UNITED STATES PATENT AND TRADEMARK OFFICE

APPLICATION NO.	FILING DATE	FIRST NAMED INVENTOR	ATTORNEY DOCKET NO.	CONFIRMATION NO.
09/755,337	01/05/2001	Yu-Lin Chen	510553.92217	3946

Office Action Summary

Sheet 1 of 2

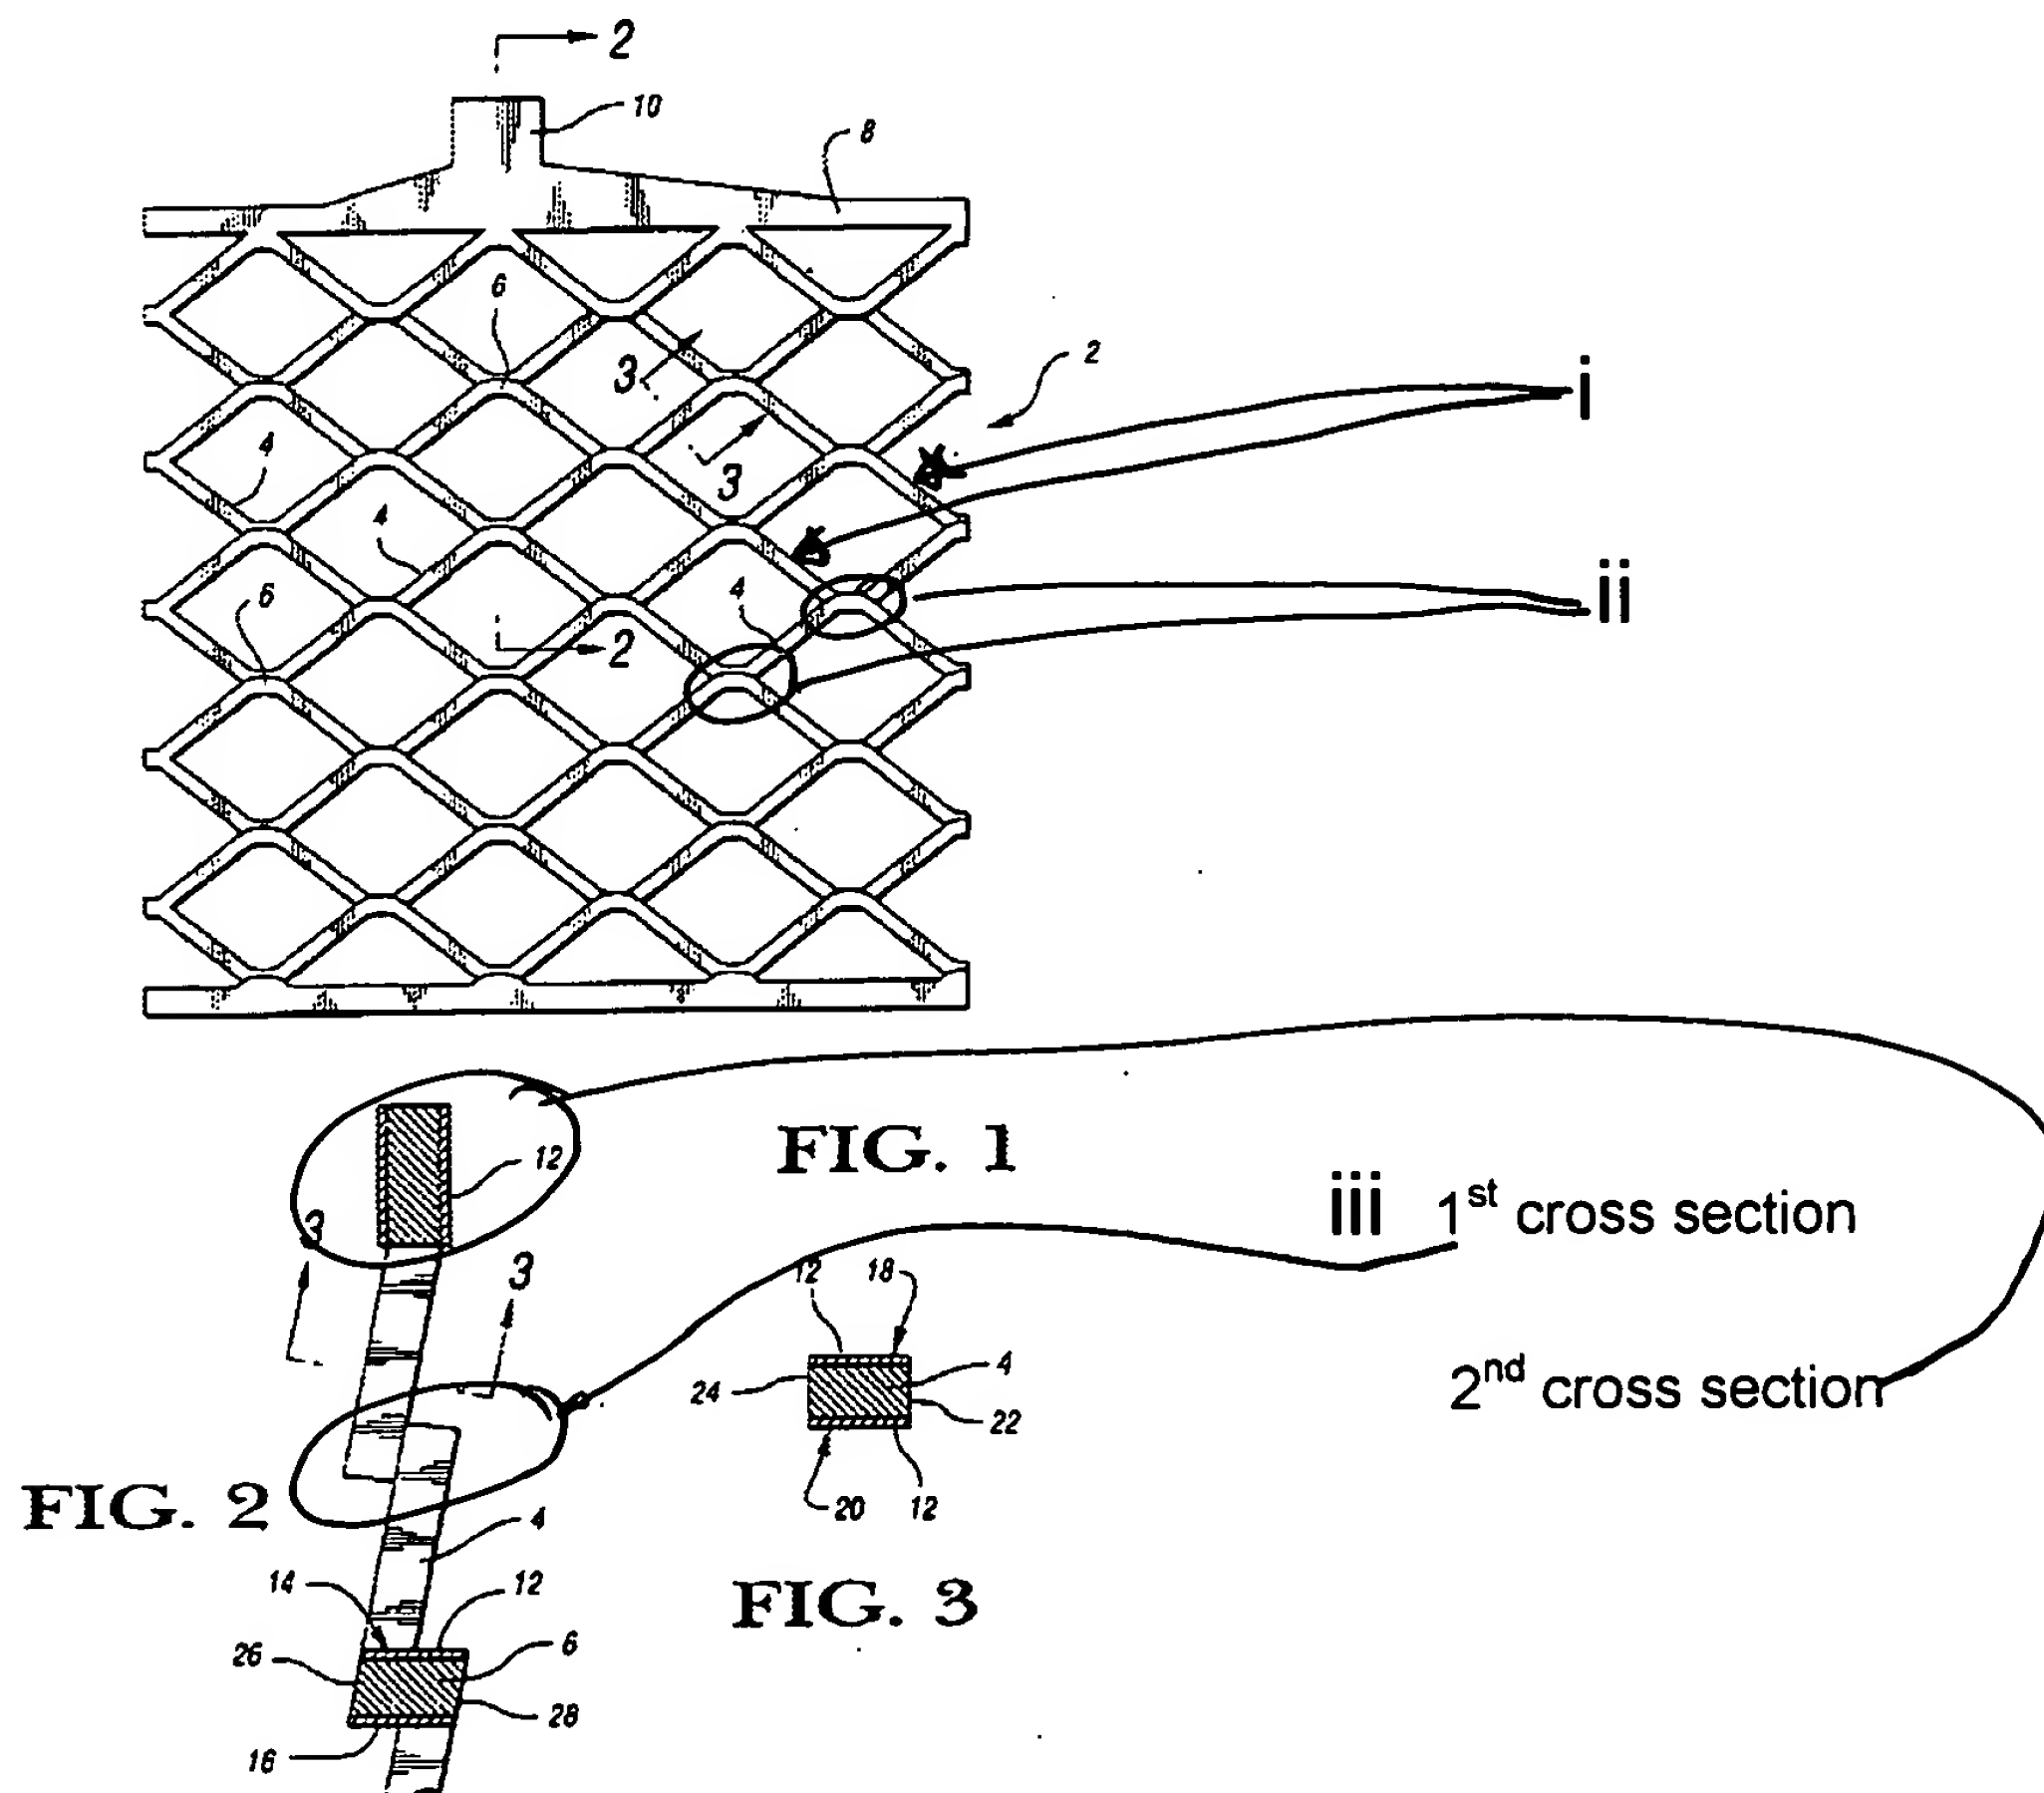
Applicant's arguments filed 07 April 2003 have been fully considered but they are not persuasive. Applicant asserts the prior art of Chang does not disclose a "network comprising a plurality of spaced apart wire elements, each wire element having opposed ends" with "at least a portion of the wire elements having a first transverse cross section taken at a position intermediate the opposed ends of the wire element and

a second transverse cross-section taken at one of the opposed ends of the wire element."

In response, it is noted that Figs 1-3 of the prior art show all of the following claimed features:

- i) a network comprising a plurality of spaced apart wire elements,
- ii) each wire element having opposed ends
- iii) at least a portion of the wire elements having a first transverse cross section taken at a position intermediate the opposed ends of the wire element and a second transverse cross section taken at one of the opposed ends of the wire element.
